Maelor Foods, Pickhill Lane, Cross Lanes, Wrexham

Variation of Condition 07 of Planning Permission APP/H6955/A/18/3216187 to Permit the Processing of 2 million Birds per Week

Introduction

From:	Chief Officer, Environment & Technical	To:	Chief Officer Planning & Regulatory
Our Ref:	ET/DC/MZ/P/2022/0820	Your Ref:	P/2022/0820 Res(1)
Date:	02/07/2024

LONG SECTION ALONG VISIBILITY SIGHT LINE TO KERB
SCALE: H 1:200, V 1:200

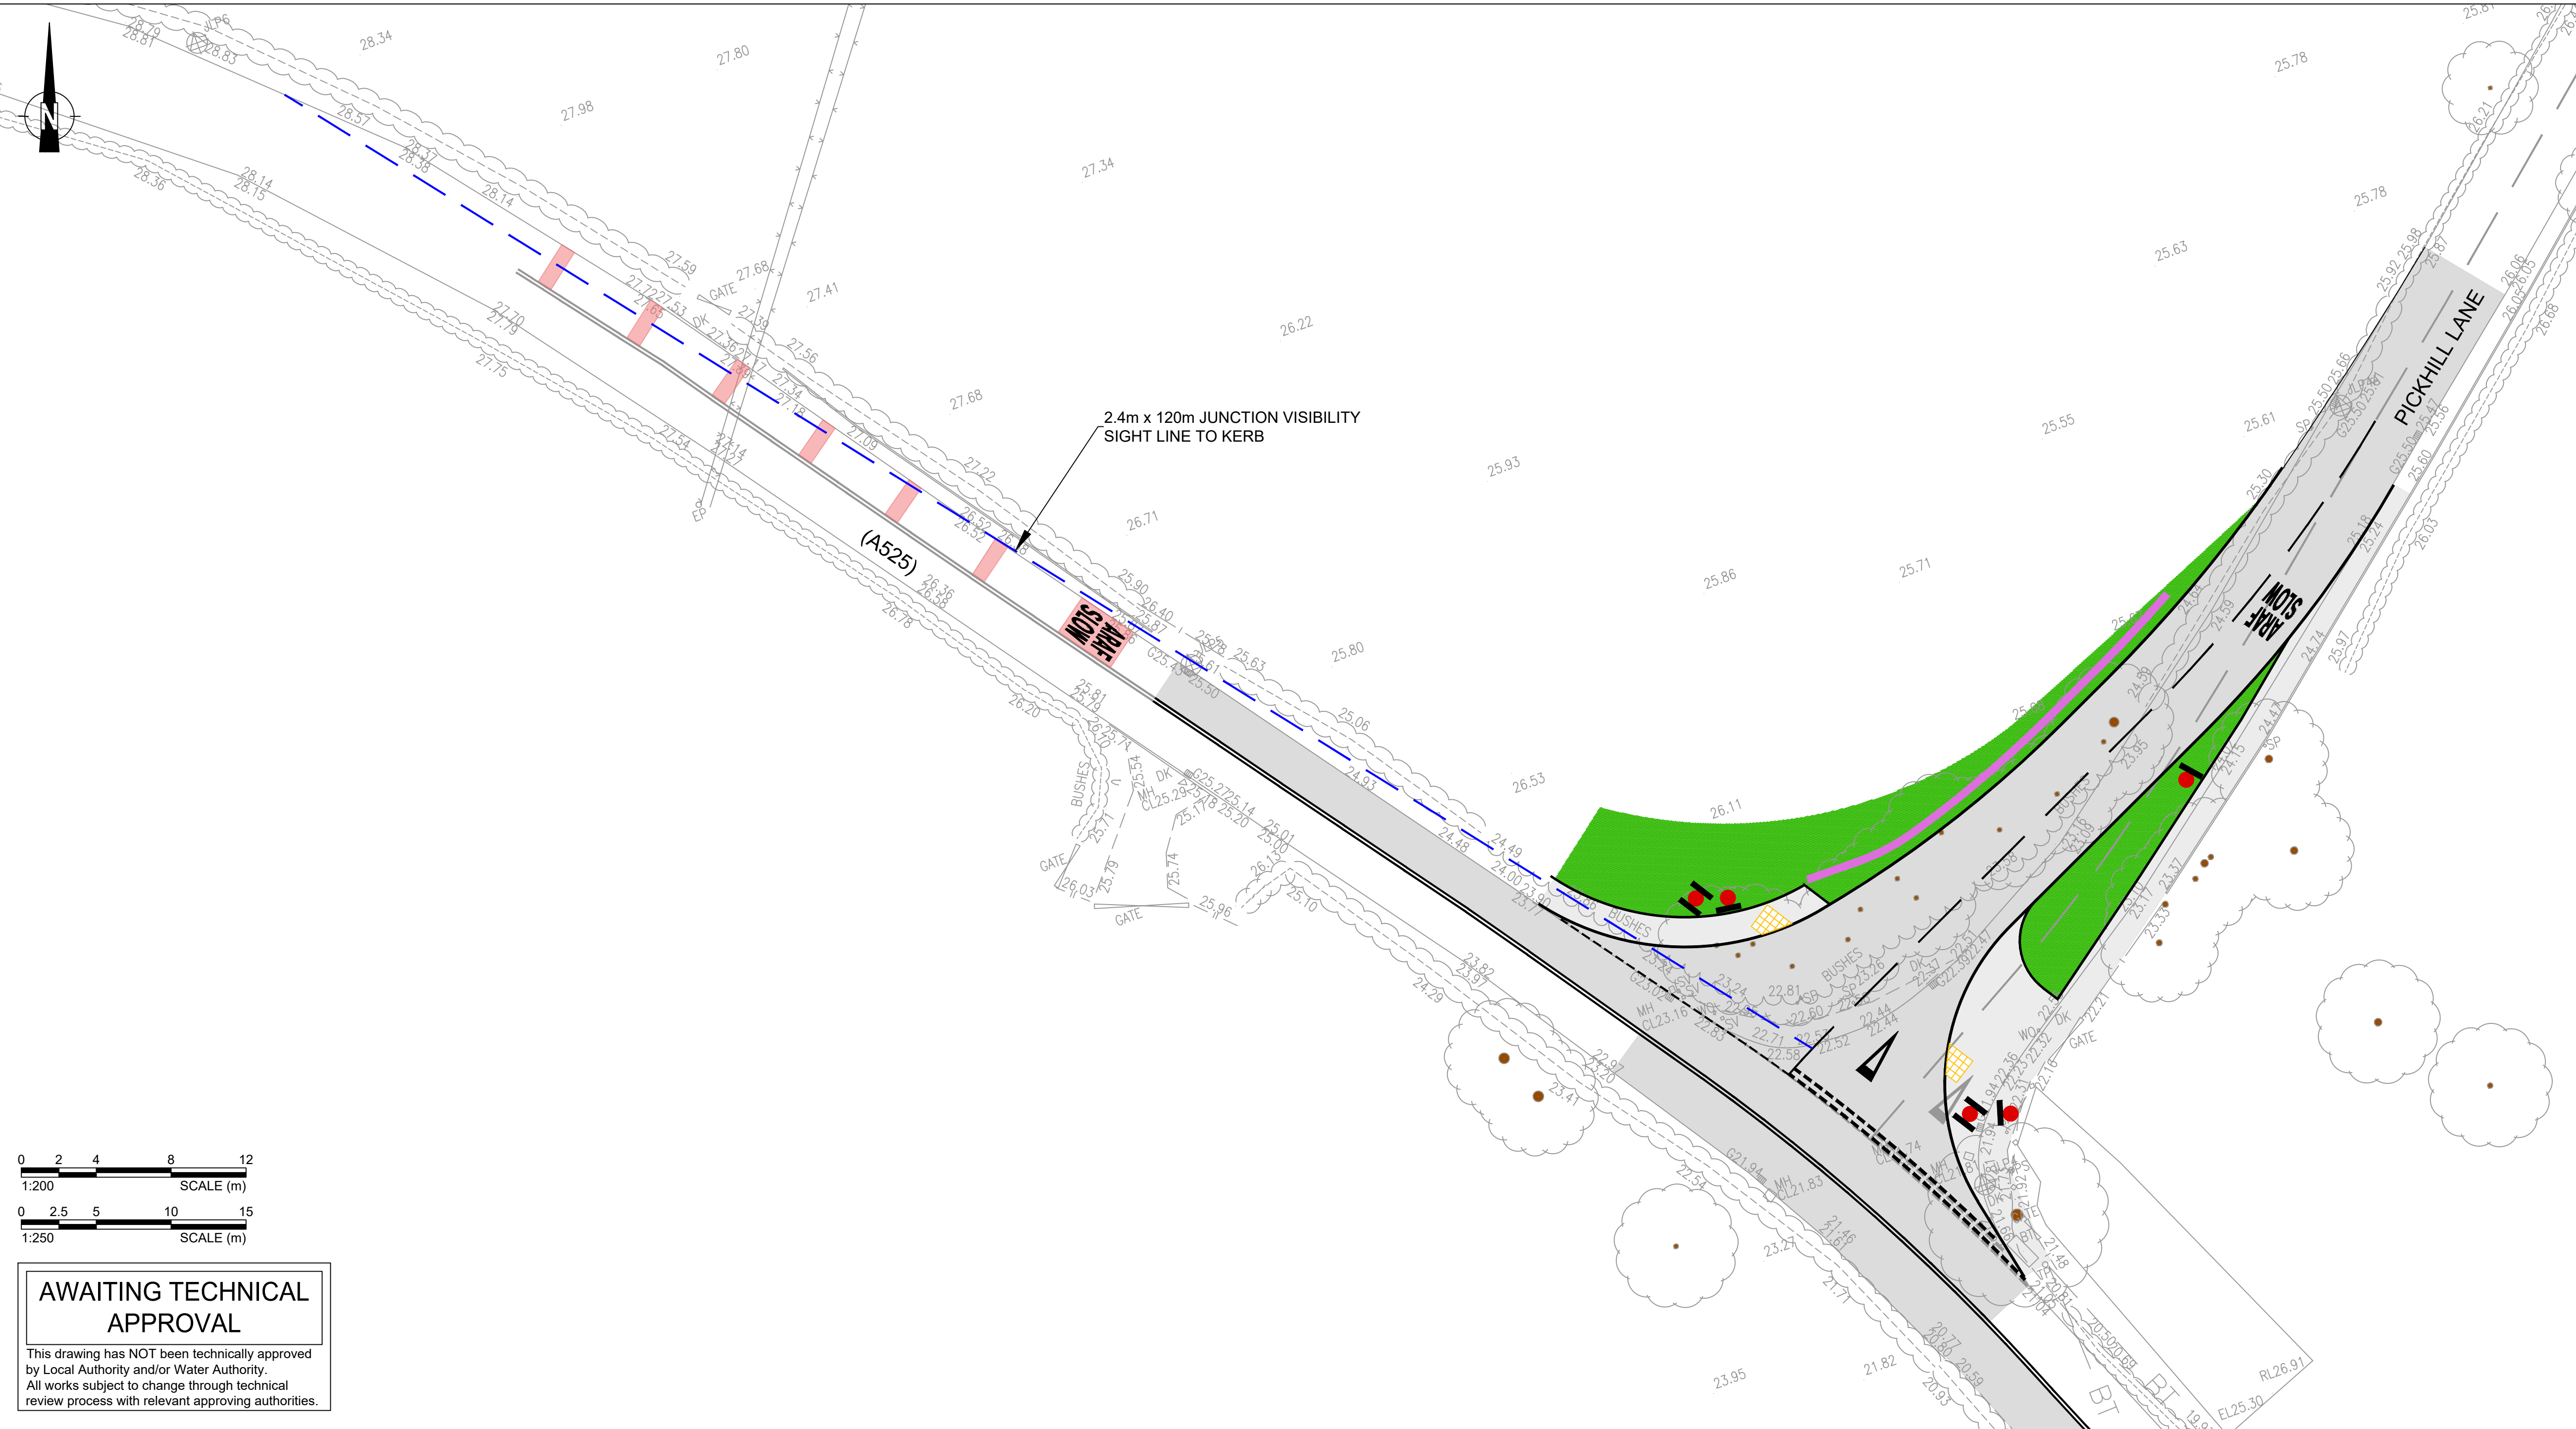
Furthermore an updated drawing with the visibility splays at the junction should be submitted.

Both horizontal and vertical visibility sightlines at the Pickhill Lane / A525 junction are presented on **Drawing VD190095/SK004** attached to the rear of this report. As is shown, suitable visibility can be achieved both in the vertical and horizontal plane and is consistent with existing visibility provided at the junction. As demonstrated by the vertical splay assessment, considering the existing road level / profile to the north, drivers have a clear and unobstructed 120m sightline from an eye height of 1.05m to an object height of 0.6m above the carriageway, ensuring no safety concerns. This height complies with the Manual for Streets (MfS) guidance.

DRAWING NUMBER: VN222301 D102

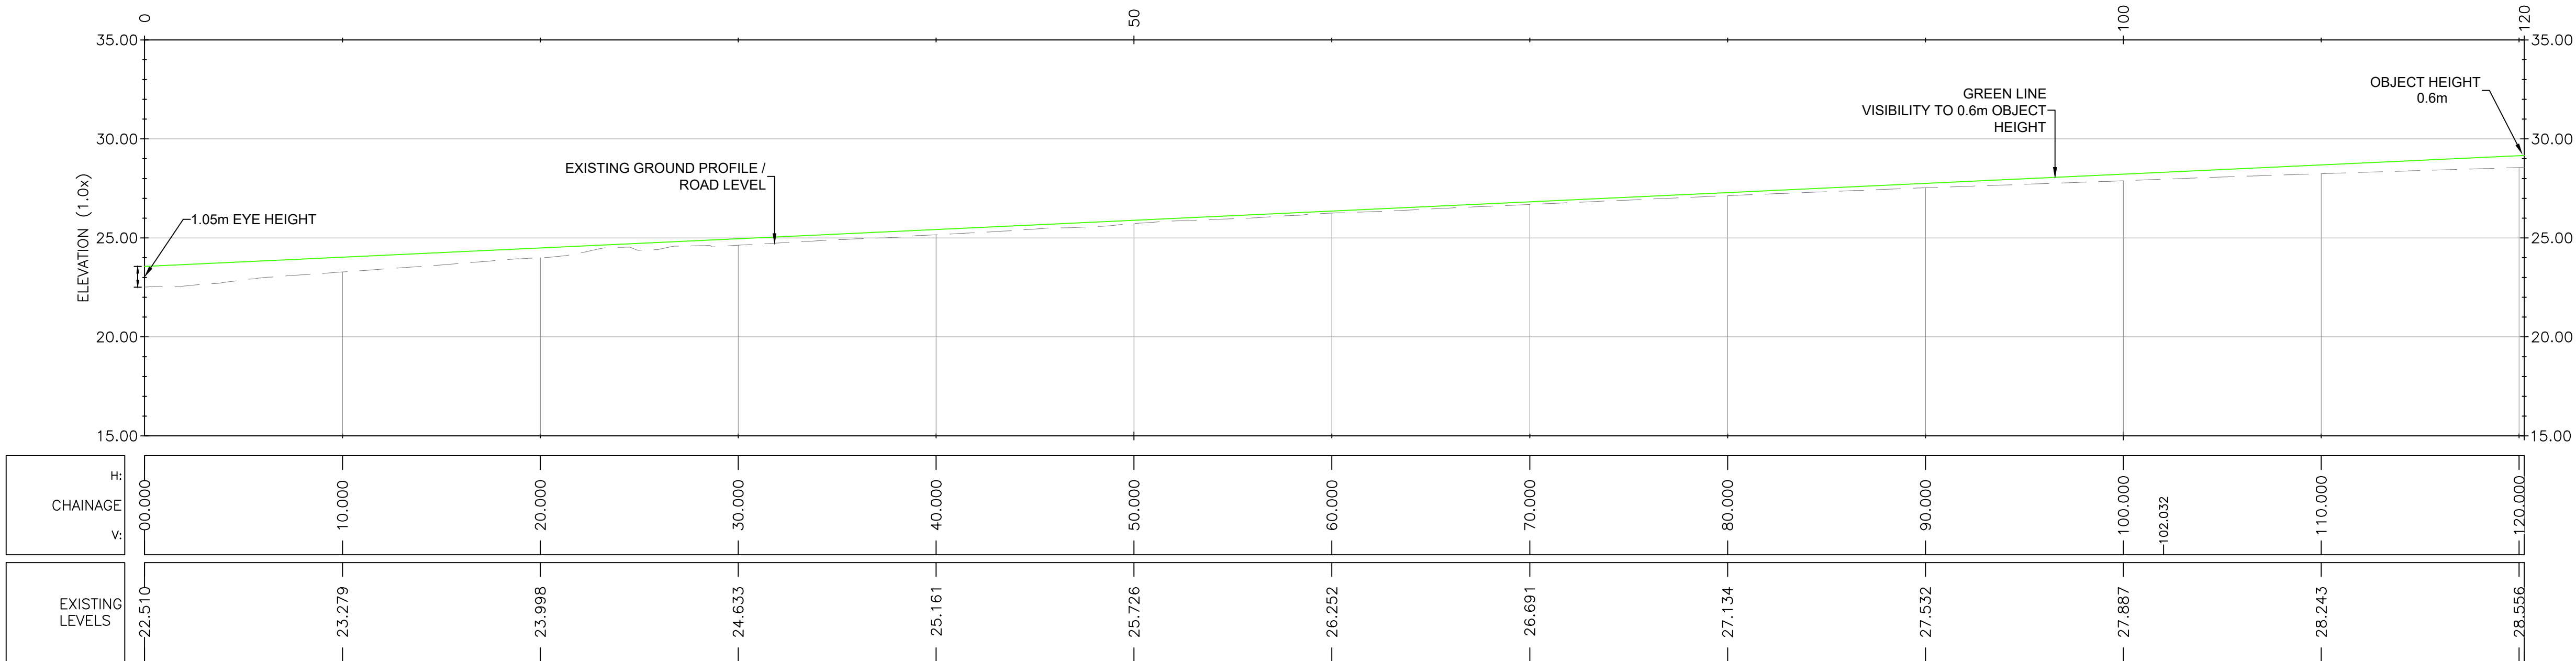
The applicant has proposed an amended layout to the junction of Pickhill Lane and the A525. It is proposed to widen the junction on the northern side to provide an 18m radius kerb on the approach to the site from the A525. Swept paths are shown for the proposed access and egress by a standard articulated vehicle. The revised junction arrangement ensures that the vehicle can turn and stay within the extents of its lane within access and egress. Dropped kerbs and tactile paving are proposed to create a level crossing point across the mouth of the junction which is an improvement and the footway is proposed to be built out on the south side of the junction. Whilst there are no objections in principle to this, the dropped kerb to access the existing farm on the south side of the junction will need to be reinstated. The existing street name sign and speed limit signs and other street furniture located at the junction will need to be re-sited, and all works to be delivered as part of a Section 278 Agreement. A Stage 1 Road Safety Audit has been provided within the further submission which has raised 9 issues that need to be addressed fully as part of the junction improvement scheme delivery, these include the resiting of a gulley and ensuring the surfacing has adequate skid resistance. Further Road Safety Audits will be required during and beyond scheme delivery. The proposed amendments to the highway have the potential to encroach beyond the public highway and therefore the applicant should ensure that the required permissions are in place. The public highway extents are shown below:

The proposed junction amendments are contained within the adopted highway. The adopted highway extents are shown in plan **VN222301-D102** as per the red dashed line.
